**Plymouth South High School**  
Plymouth, MA  
Ai3 Project # - 1308.00

**Addendum #2**

June 11, 2015

DRAWN BY:	MG	<b>SKFP-007</b>
SCALE:	1/8"=1'-0"	
JOB NO:	1308.00	
DATE:	6/11/2015	
REF DWG:	FP1.15

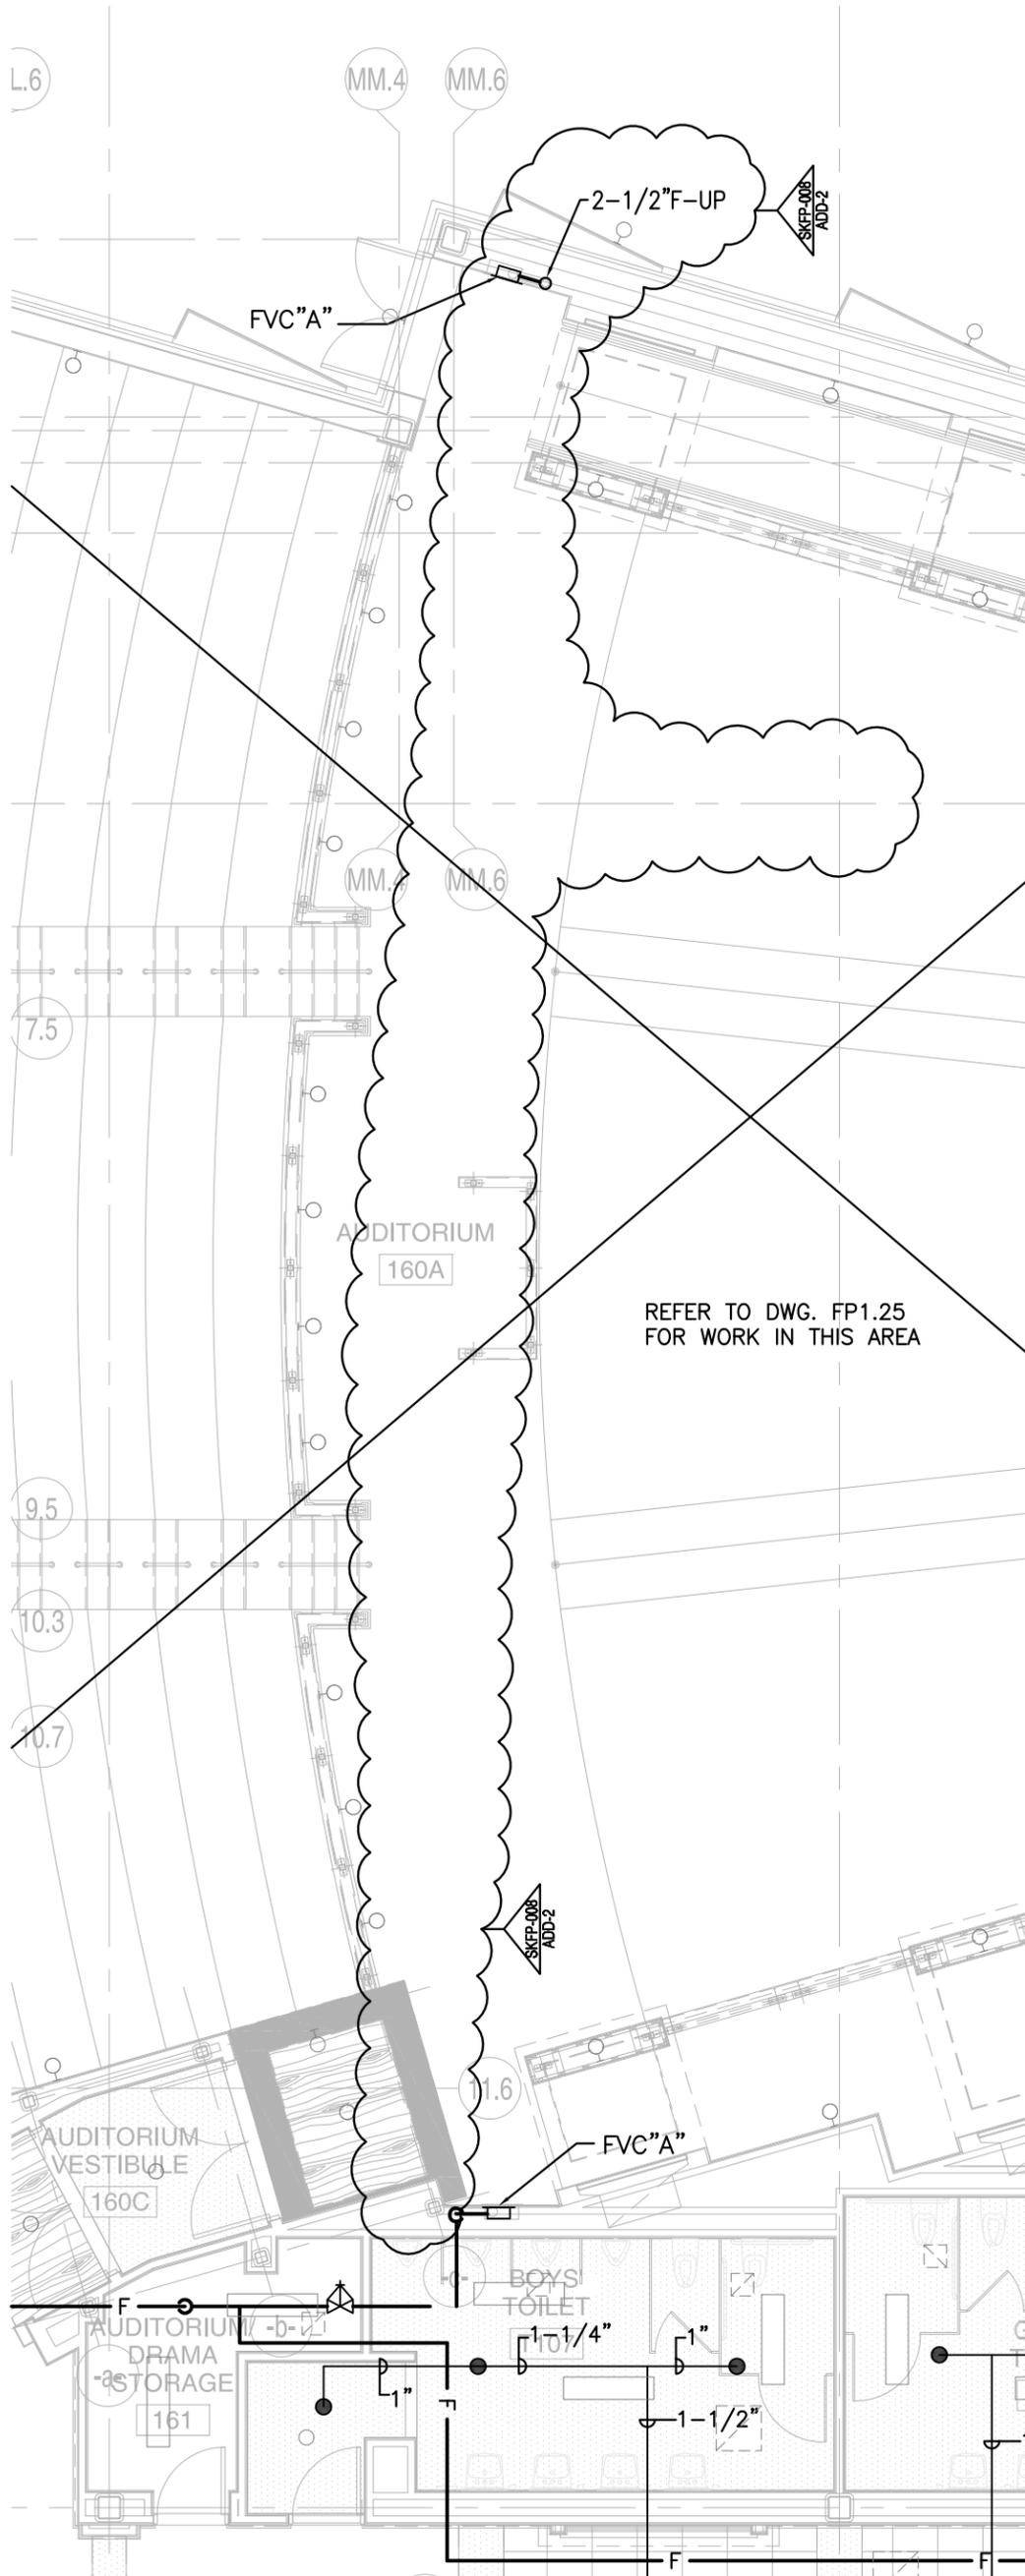
- ADD 2-0212     Drawing FP1.15 First Floor Plan Zone 5  
                  REMOVE fire main from under slab of Auditorium  
                  Relocate FVC cabinet South in same corridor  
                  Relocate FVC to stage

DRAWN BY:	MG	<b>SKFP-009</b>
SCALE:	1/8"=1'-0"	
JOB NO:	1308.00	
DATE:	6/11/2015	
REF DWG:	FP1.16

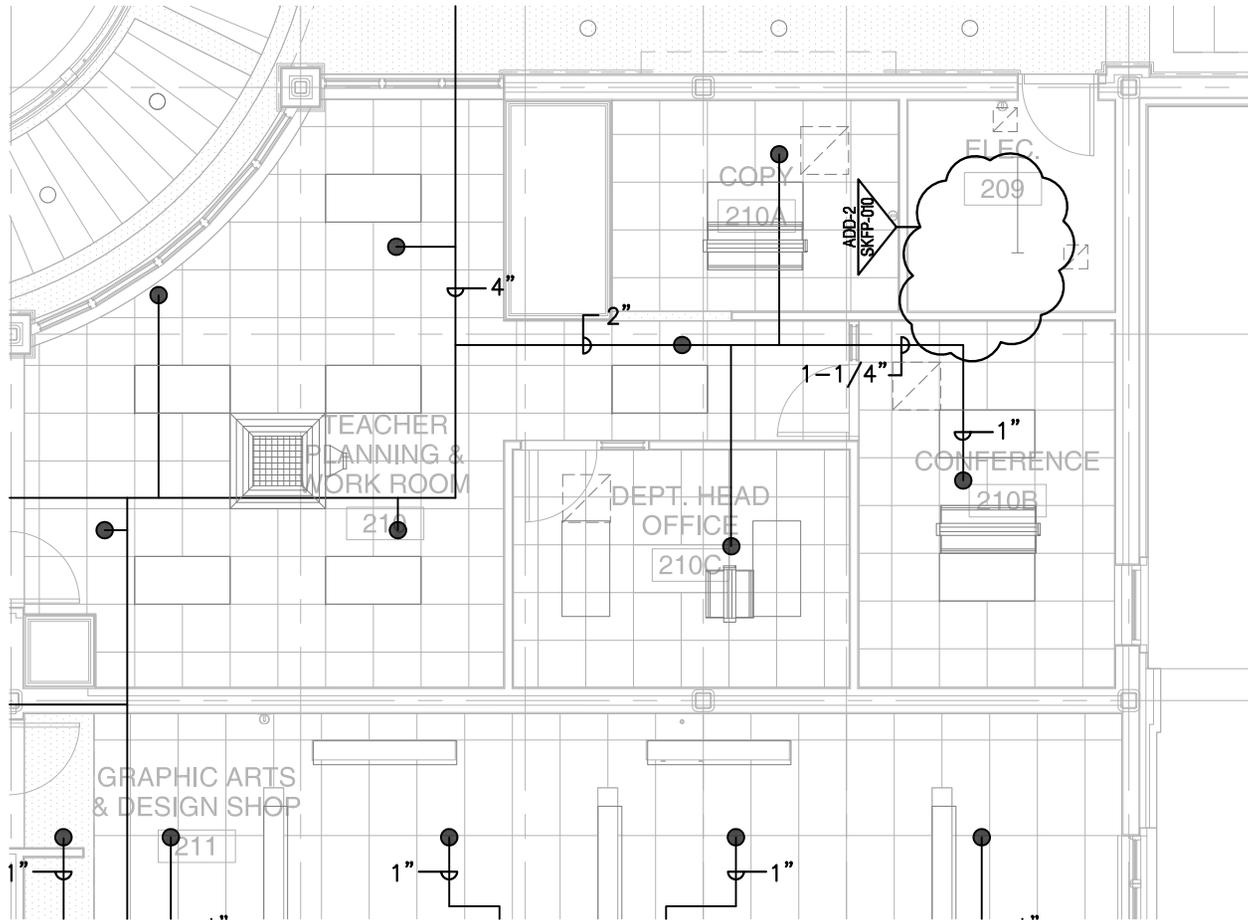
- ADD 2-0213     Drawing FP1.16 First Floor Plan Zone 6 & 7  
                  REMOVE sprinkler head from Electric Room
- ADD 2-0214     Drawing FP2.11 Second Floor Plan Zone 1  
                  REMOVE sprinkler head from Electric Room

DRAWN BY:	MG	<b>SKFP-013</b>
SCALE:	1/8"=1'-0"	
JOB NO:	1308.00	
DATE:	6/11/2015	
REF DWG:	FP1.31

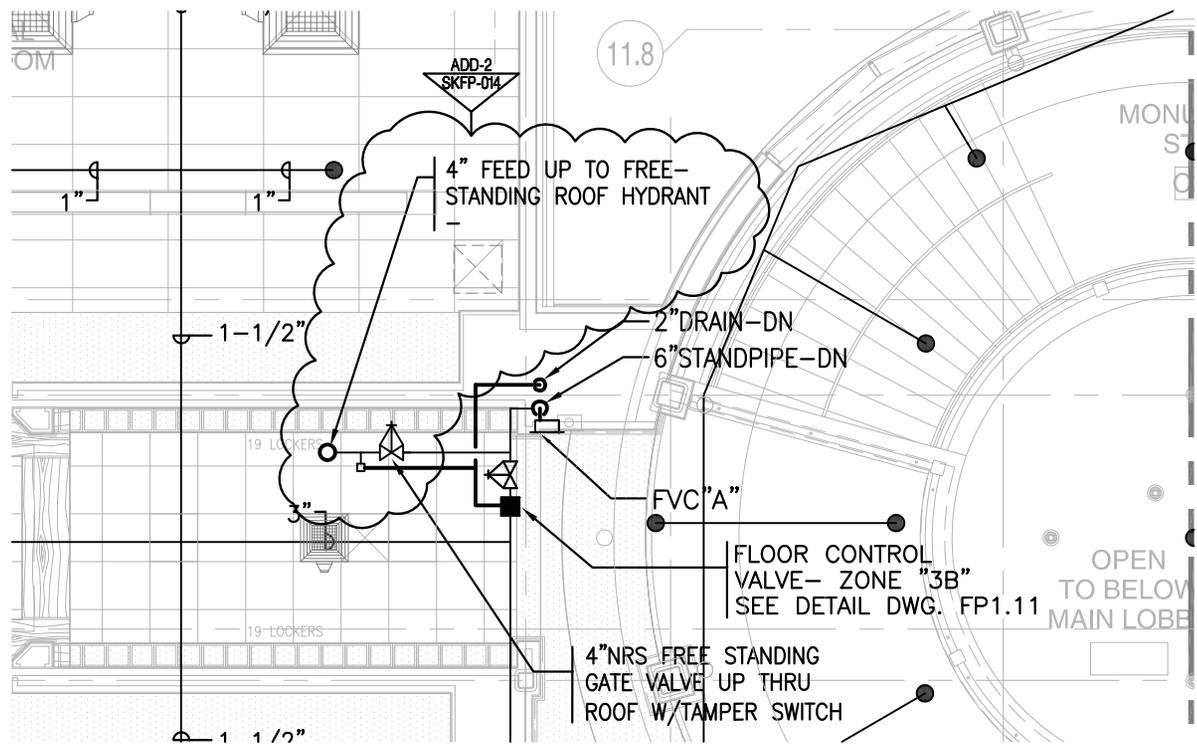
- ADD 2-0217     Drawing FP1.31 Third Floor Plan Zone 1  
                  REMOVE check valve
- ADD 2-0218     Drawing FP1.33 Third Floor Plan Zone 3  
                  REMOVE check valve

DRAWN BY:	MG	SKP-017
SCALE:	1/8"=1'-0"	
JOB NO:	1308.00	
DATE:	6/11/2015	
REF DWG:		P1.15

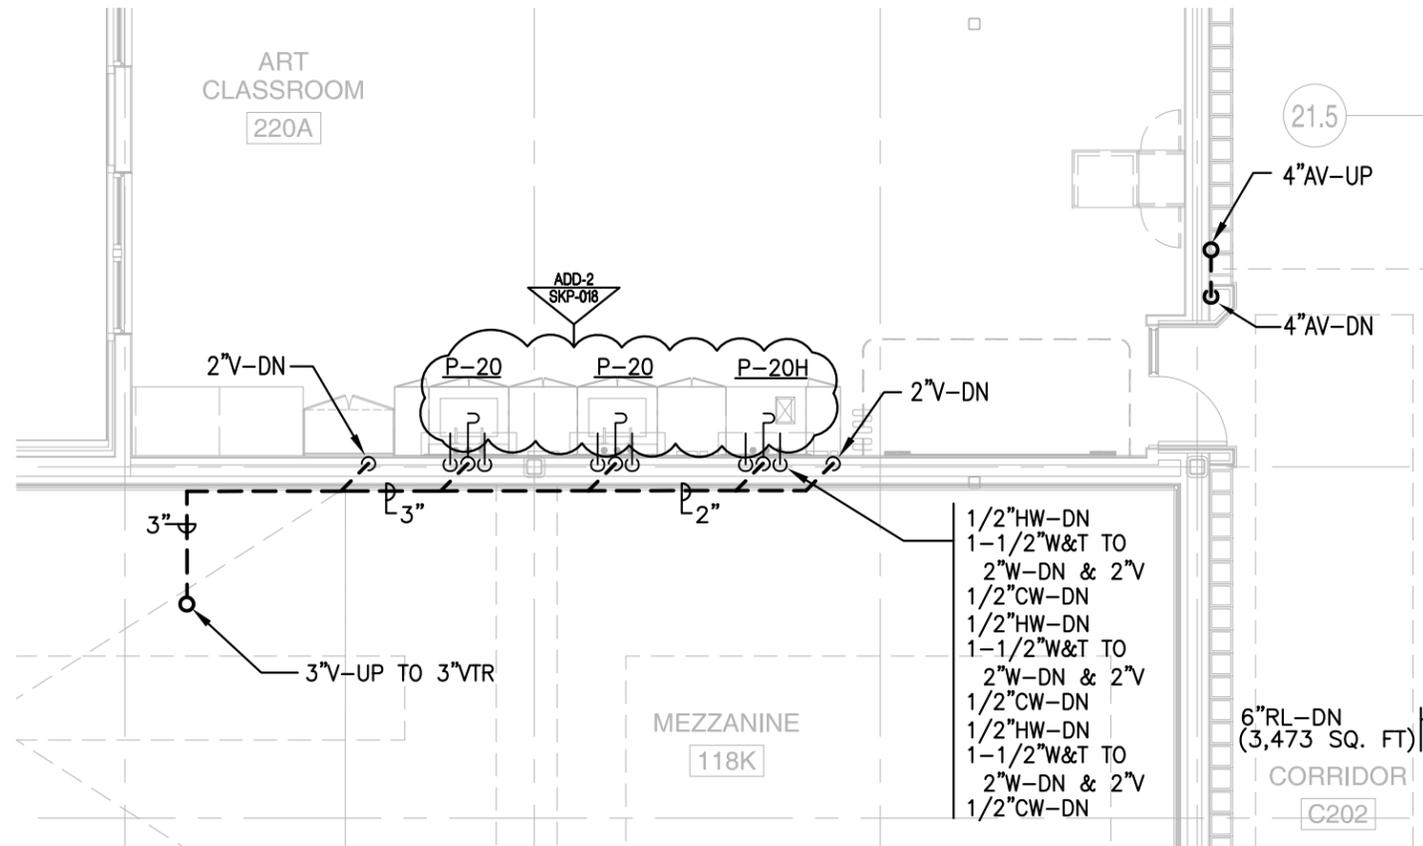
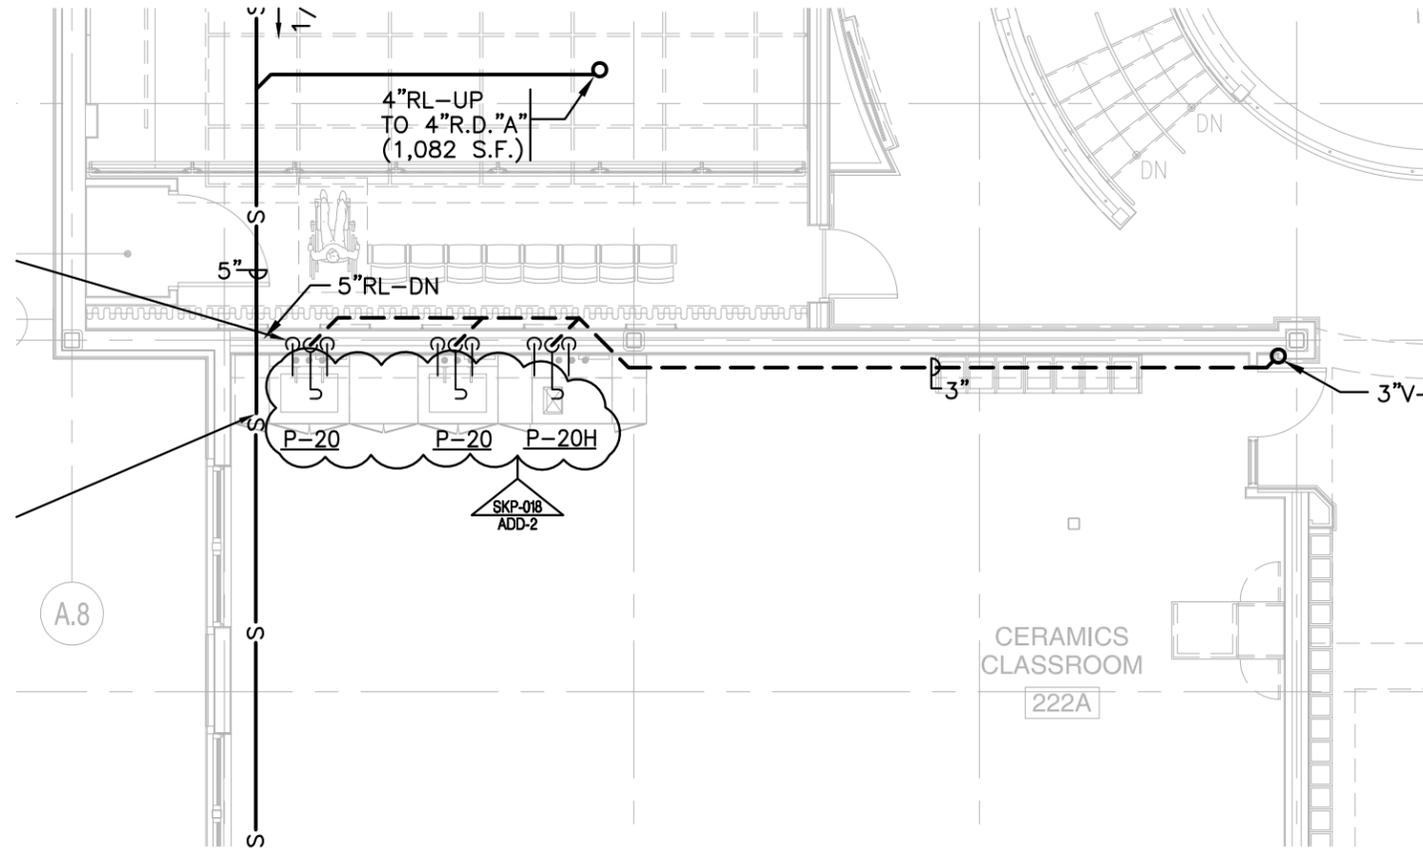
- ADD 2-0220     Drawing P1.15 First Floor Plan Zone 5  
                  ADD floor drain and piping with notes.
- ADD 2-0221     Drawing P1.21 Second Floor Plan Zone 1  
                  Change P-16's back to P-20's

DRAWN BY:	MG	<b>SKP-019</b> REF DWG: P1.23
SCALE:	1/8"=1'-0"	
JOB NO:	1308.00	
DATE:	6/11/2015

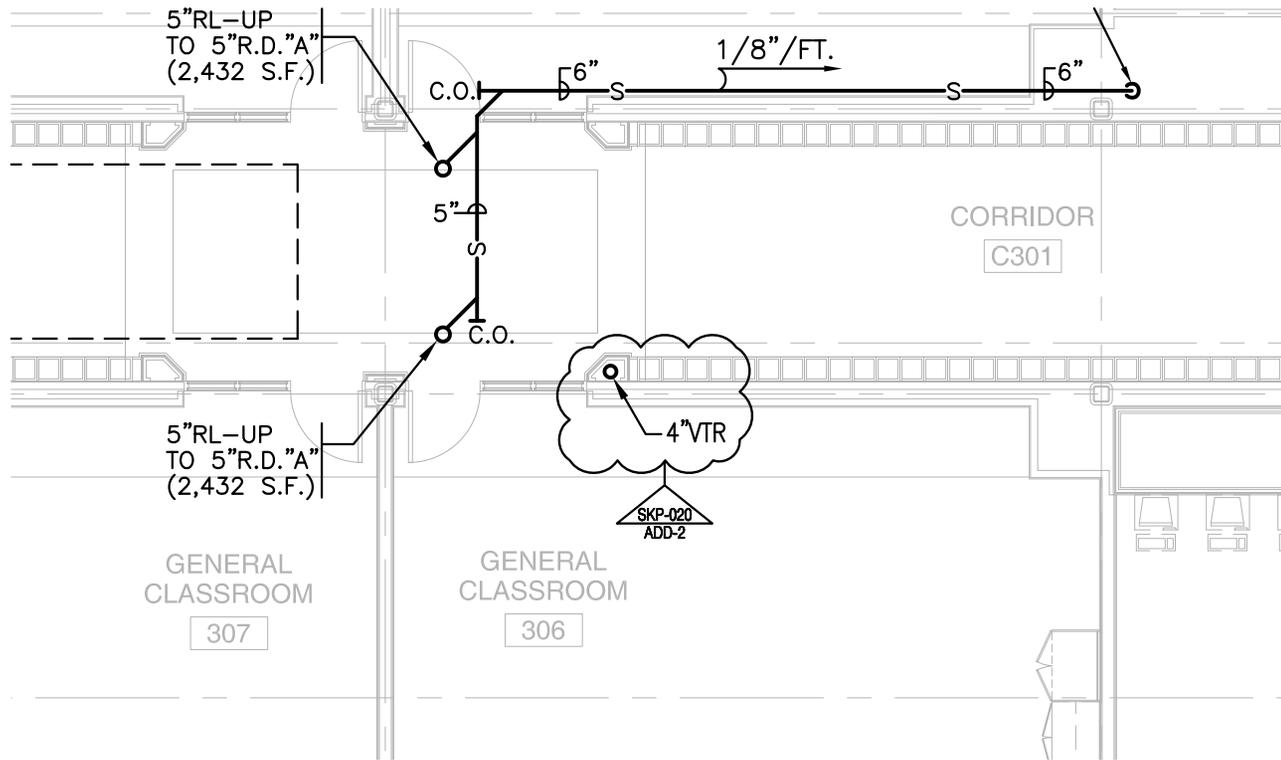
- ADD 2-0222     Drawing P1.23 Second Floor Plan Zone 3  
                  ADD note, 4 inch vent riser
- ADD 2-0223     Drawing P1.33 Third Floor Plan Zone 3  
                  ADD note, 4 inch vent thru roof

DRAWN BY:	MG	SKP-021
SCALE:	1/8"=1'-0"	
JOB NO:	1308.00	
DATE:	6/11/2015	
REF DWG:	P2.1

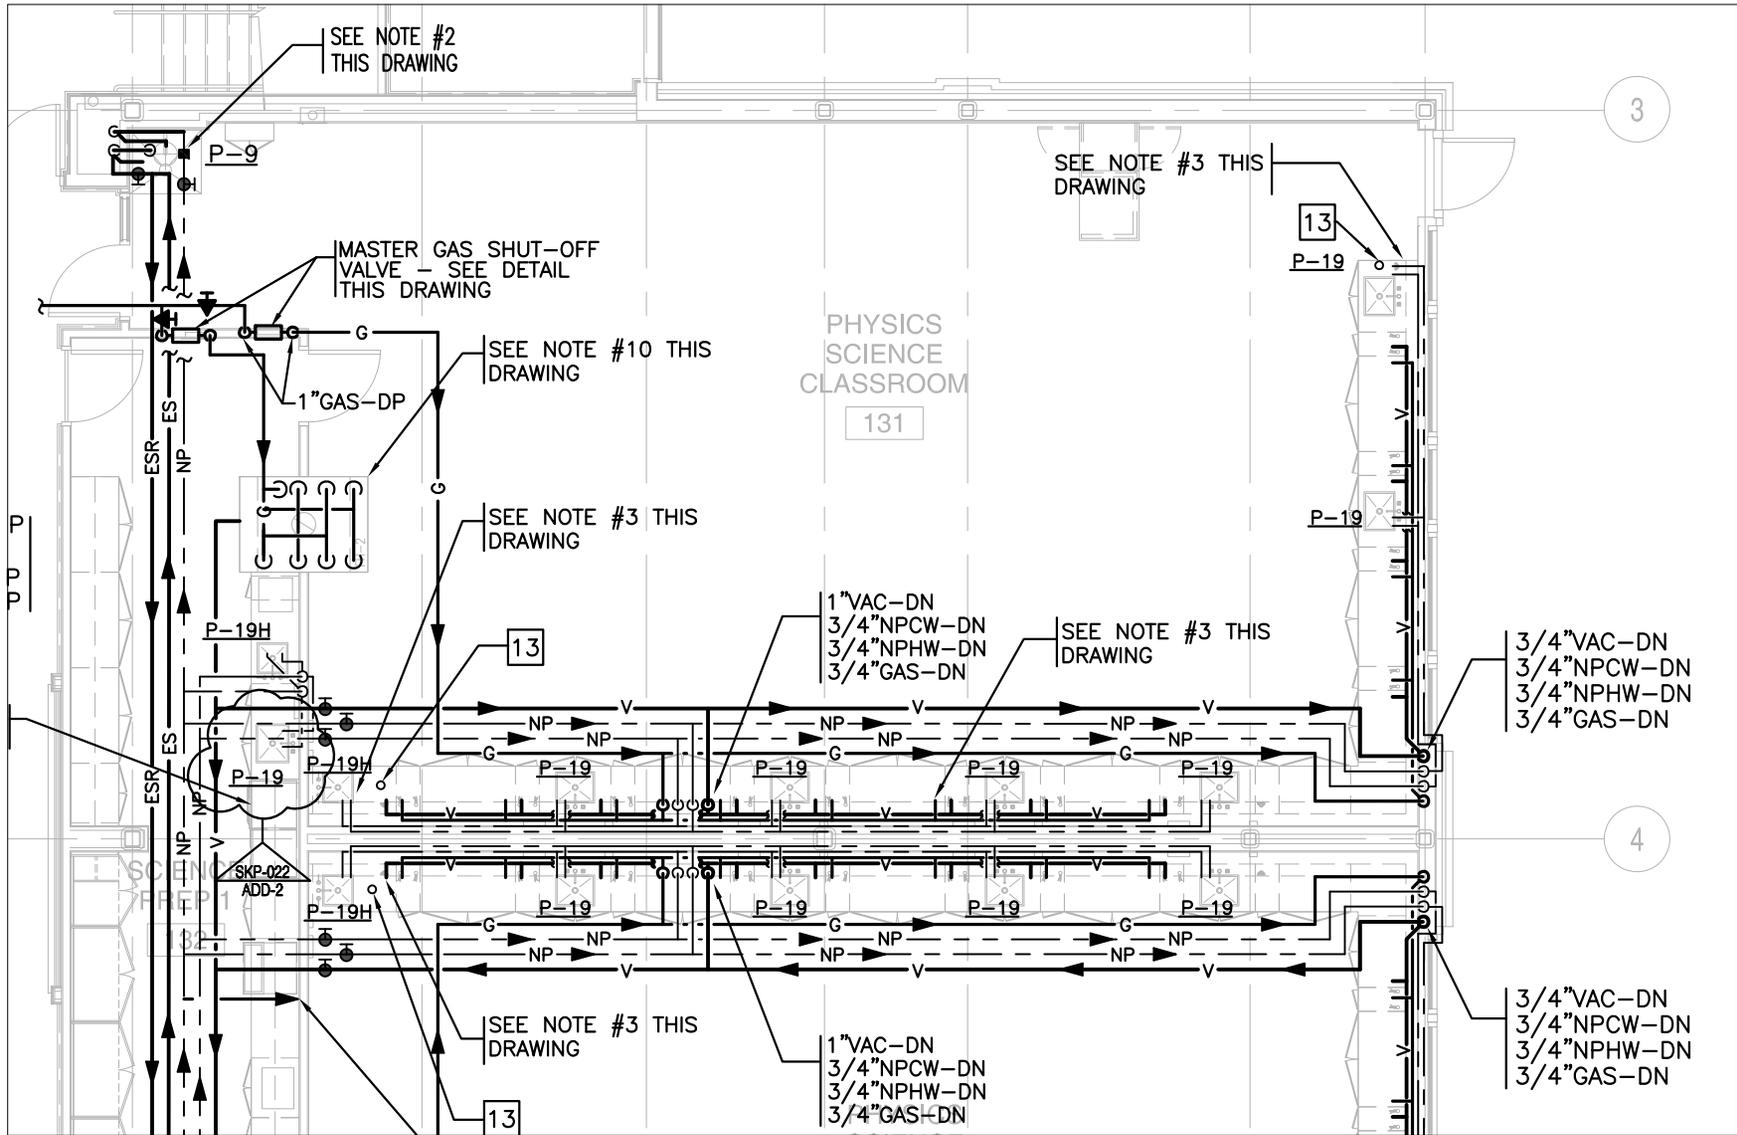
- ADD 2-0224     Drawing P2.1 Toilet Room Water Piping Part Plans  
                  Training Room, replace P-11 and P-21
- ADD 2-0225     Drawing P2.4 Science Classrooms Plans & Details  
                  Change P-12 to P-19
